Possible Issues with P240 Solution

Meeting Name	Offshore BMU Configuration Working Group
Meeting Date	18 October 2011
Purpose of paper	For Discussion
Summary	This paper identifies two possible issues with the definition of 'Switching Group' introduced into the Balancing and Settlement Code (BSC) by Modification Proposal P240.

Figure 1 – P240 Example 1

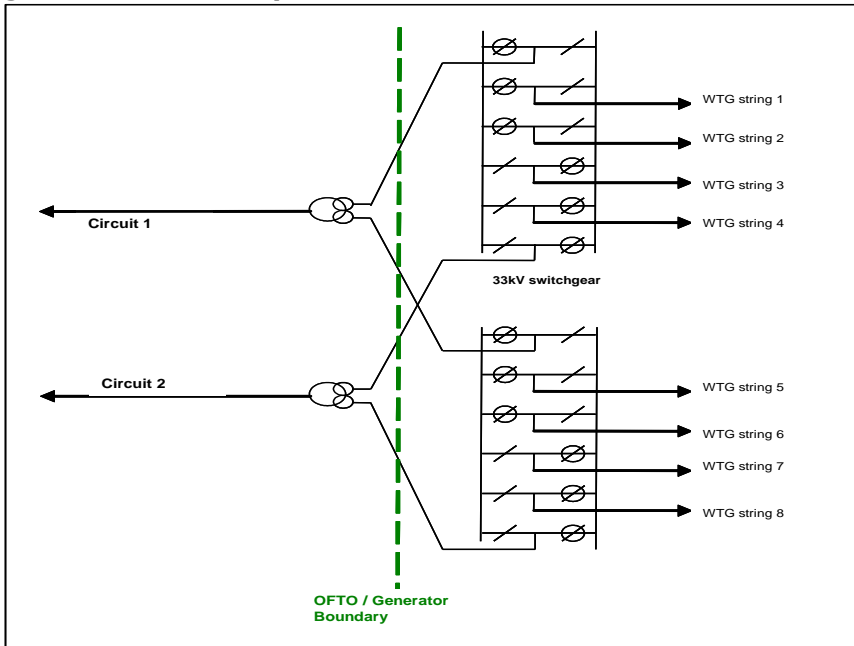
- 4.2 Unfortunately the Modification Report does not explicitly identify the Power Park Modules or Switching Groups. However, the intent seems reasonably clear:

- 4.2.1 The report refers to four BM Units, each of which must have corresponded (under the pre-P237 baseline) to a single PPM. The Modification Group therefore seems to have assumed that the Power Park Strings connected to each of the four Boundary Points would have formed a Power Park Module (and hence a BM Unit). For example, with the switches set as shown in the diagram, the BM Units would be as follows:

- WTG strings 7 and 8 form a PPM/BMU ('BM Unit D').
- 4.2.2 Changing the switch settings would allow Power Park Strings to move between BM Units A and B, or between BM Units C and D (but not from A or B to C or D, or vice versa). The P240 legal text would therefore require BM Units A and B to be treated as one Switching Group, and BM Units C and D to be treated as another (in accordance with K3.1.4B, which requires that "Plant and Apparatus can be selected to run in any of the BM Units belonging to that Switching Group").

- 4.3 In summary, we do not believe that there are any issues with this example. The P240 legal text does not place any unnecessary constraints on how the switches are operated, and it is clear how Switching Groups should be registered.

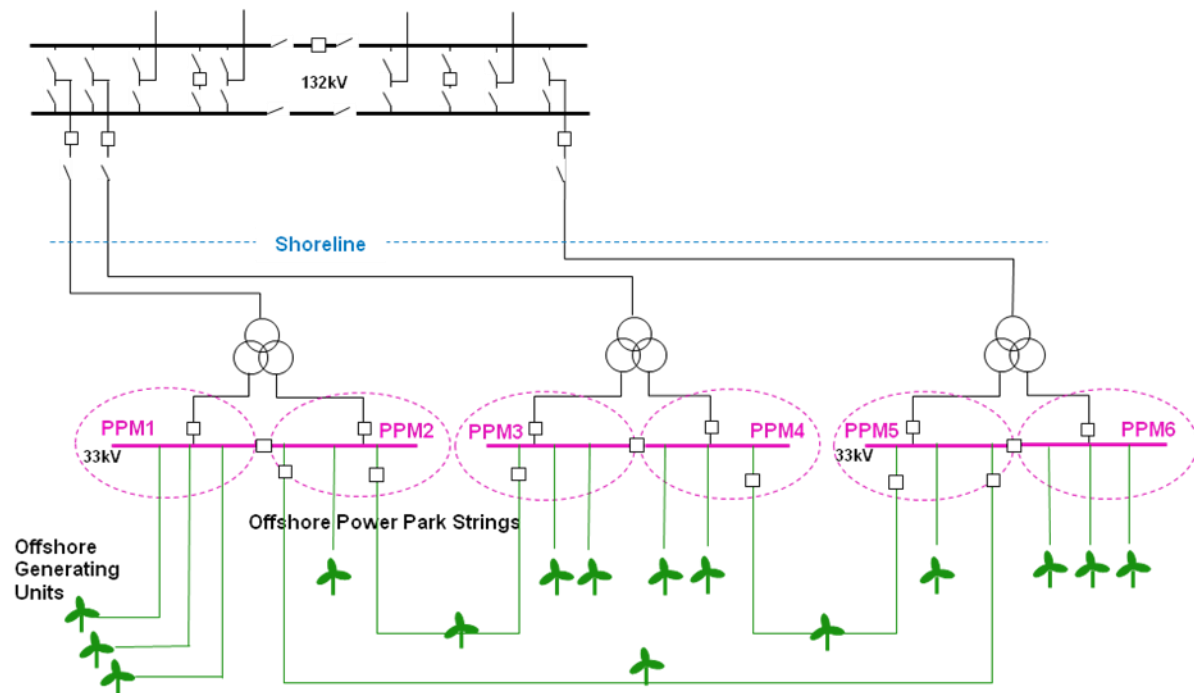
5.2 Unfortunately, because there are now multiple PPMs in each BM Unit, we believe it may be possible to interpret the P240 legal text in two different ways:

- One interpretation is that **BM Units** are assigned to Switching Groups. Under this interpretation the two BM Units have to be assigned to a single Switching Group (as Plant and Apparatus can be switched between them).
- Another possible interpretation is that **PPMs** are assigned to Switching Groups (with the possibility of different PPMs within the same BM Unit being assigned to different Switching Groups). This would allow PPM1 and PPM2 to form one Switching Group, and PPM3 and PPM4 to form another.

5.3 We believe that the first interpretation was the intended one. PPMs are not registered under the BSC, so there is no mechanism for Parties to register PPMs to Switching Groups; and the registration requirements in BSC paragraph K3.2.3 and BSCP15 clearly indicate that each BM Unit (not each PPM) is intended to belong to a single Switching Group. However, we acknowledge that some aspects of the P240 legal text are not as clear on this point as they could be. For example:

- K3.1.4A defines a Switching Group as "a combination of Power Park Modules" (although it does then go on to refer to BM Units "belonging to that Switching Group"); and
- K3.1.4D states that a PPM "may not belong to more than one Switching Group at any given time", apparently leaving open the possibility that a single BM Unit could belong to more than one Switching Group.

5.4 We believe that there may be an argument for amending these paragraphs to clarify that a BM Unit can only be registered to a single Switching Group.

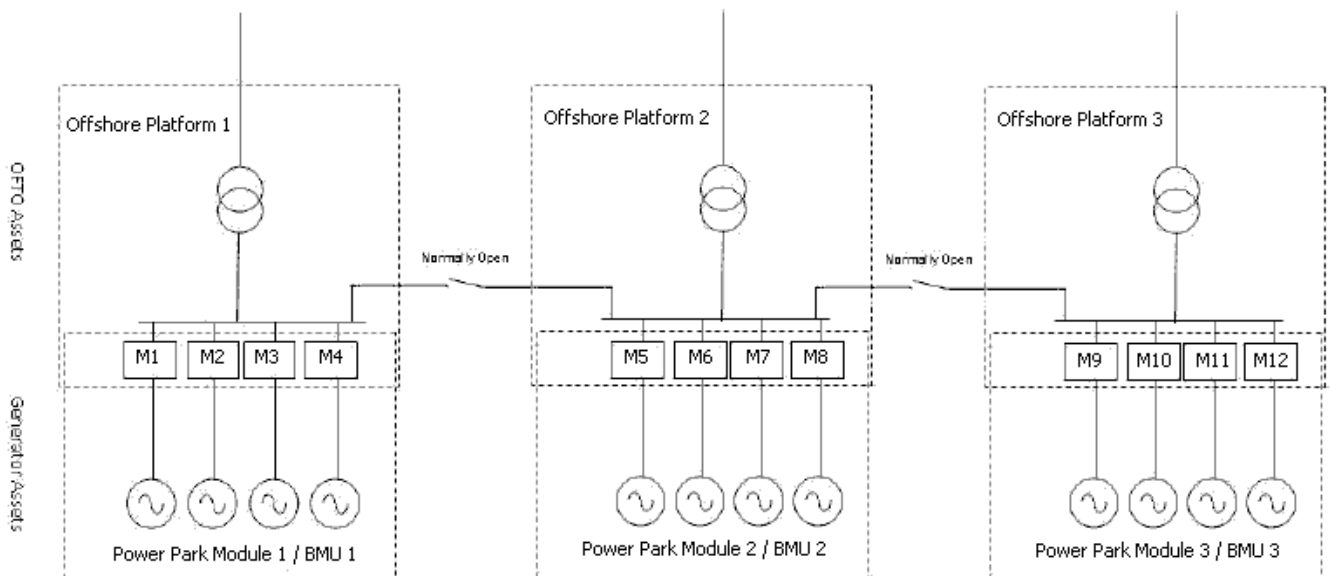
6.2 In this example, busbar switches can be closed to join PPM1 to PPM2; or PPM3 to PPM4; or PPM5 to PPM6. This does not in itself involve any switching of Plant and Apparatus between PPMs or BM Units. However, there are also 'loop' connections that allow turbines to be switched between PPM2 and PPM3; PPM2 and PPM5; or PPM4 and PPM5.

6.3 One registration option for this site would be to register six BM Units (one per PPM). However, the K3.1.4B requirement that "Power Park Modules may belong to a Switching Group on the basis that Plant and Apparatus can be selected to run in any of the BM Units belonging to that Switching Group" would then make it impossible to define appropriate Switching Groups. For example, PPM2 would need to be in the same Switching Group as PPM3 and PPM5; but PPM3 cannot be in the same Switching Group as PPM5 because Plant and Apparatus in PPM3 cannot be switched into PPM5.

- 6.5 However, the three-BMU configuration would still not allow Switching Groups to be defined in a manner consistent with K3.1.4B. It still remains the case that PPM2 would need to be in the same Switching Group as PPM3 and PPM5; but PPM3 cannot be in the same Switching Group as PPM5 because Plant and Apparatus in PPM3 cannot be switched into BM Unit C.
- 6.6 In summary, paragraph K3.1.4B is inconsistent with any configuration in which a BM Unit can exchange Plant and Apparatus with two other BM Units; but those two BM Units cannot exchange Plant and Apparatus with each other. Here is another example, based on one in BSCP75 ('Registration of Meter Aggregation Rules For Volume Allocation Units'), but amended to have three offshore platforms rather than two:

- 6.7 There does not appear to be any reason why the BSC should prevent such configurations, and we do not believe that the P240 Modification Group intended to exclude them. They were simply not considered at the time.

- 7.4 However, K3.1.4B goes too far by preventing any configuration in which a BM Unit can exchange Plant and Apparatus with two other BM Units; but those two BM Units cannot exchange Plant and Apparatus with each other. We believe it needs to be replaced by a weaker and more appropriate constraint. The exact form this takes would need to be considered by a Modification Group, but one possible approach would be to define a Switching Group as a collection of BM Units that satisfies three conditions:

- Each BM Unit in the Switching Group can exchange Plant and Apparatus with one or more other BM Units in the Switching Group;
 - No BM Unit in the Switching Group can exchange Plant and Apparatus with BM Units outside the Switching Group; and

- No smaller collection of BM Units meets the above conditions. (This last condition prevents unconnected Switching Groups from being consolidated unnecessarily).
